SERVICE BULLETIN

SB No. 101 Issue No. 1

TITLE INSPECTION AND REPLACEMENT OF FLAP TORQUE TUBE BEARING AT RIB 2

Fig 1
View looking Outbd onto Stbd Wing
Rib 2. Port similar

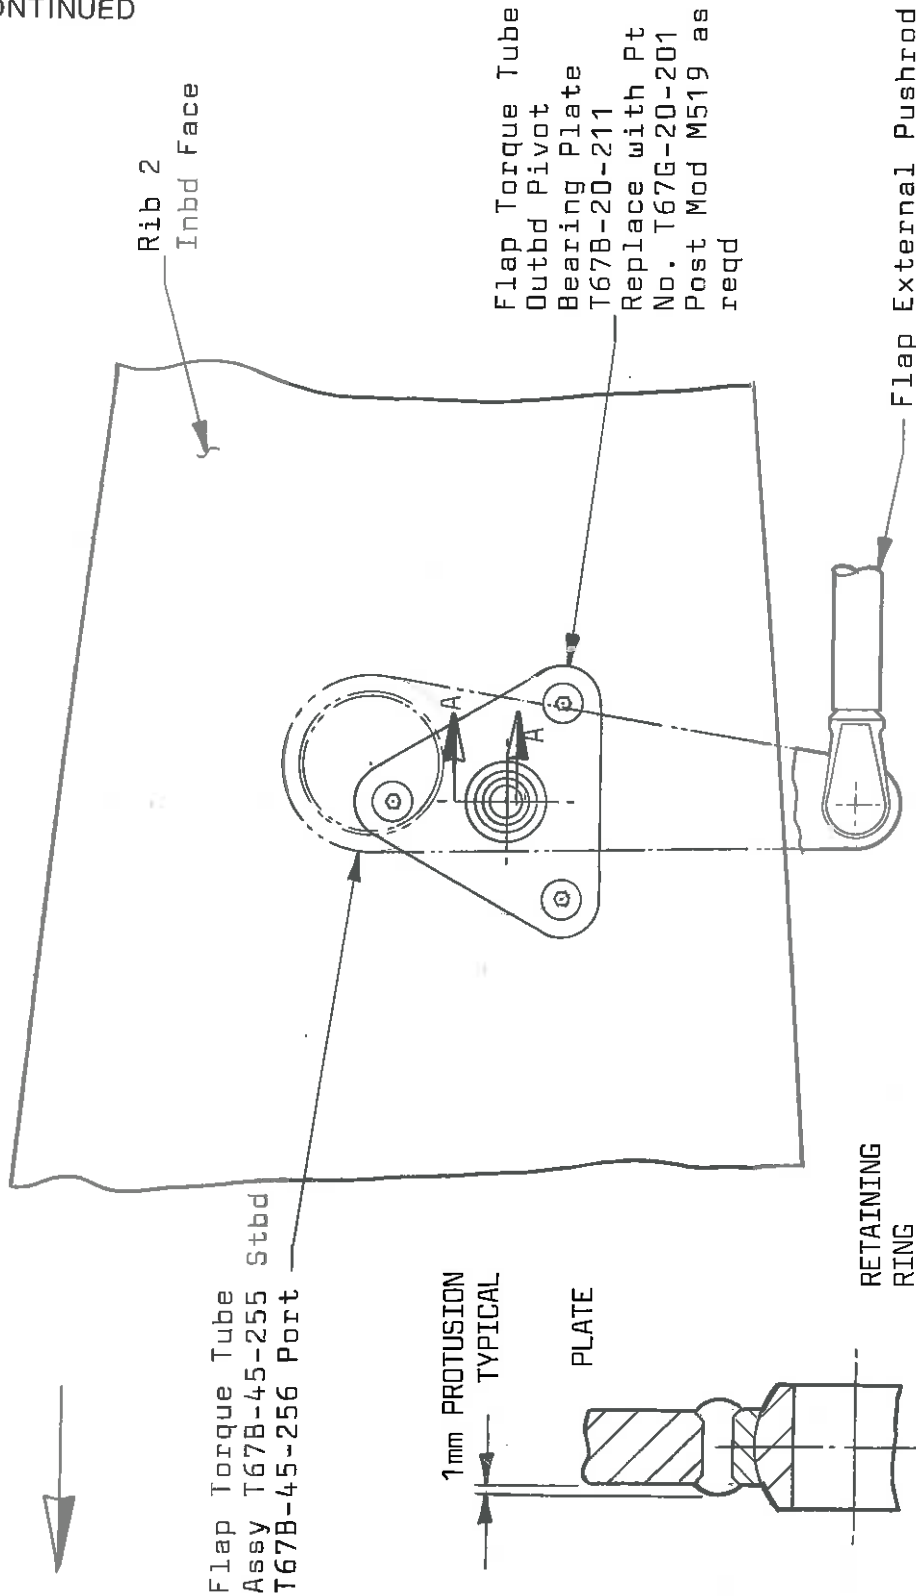
1. Gain access to Rib 1 and remove flap torque tube.
2. Inspect bearing for retention in mounting plate. Should be .5mm max protrusion. Check by pushing on bearing. If in doubt remove bearing plate from rib and check retention, See Section 'AA', Page 2.
3. If retention unsatisfactory, remove both port and starboard bearing plates T67B-20-211 and replace with Part No. T67G-20-201.
4. On completion of Service Bulletin, annotate in logbook SB 101 complied with. Mod M519 invoked.

RETAINING RING
BEARING
SECTION A-A
SHOWING CORRECT BEARING RETENTION
SCALE 2:1

1mm PROTRUSION TYPICAL

Flap Torque Tube Outbd Pivot Bearing Plate T67B-20-211 Replace with Pt No. T67G-20-201 Post Mod M519 as reqd
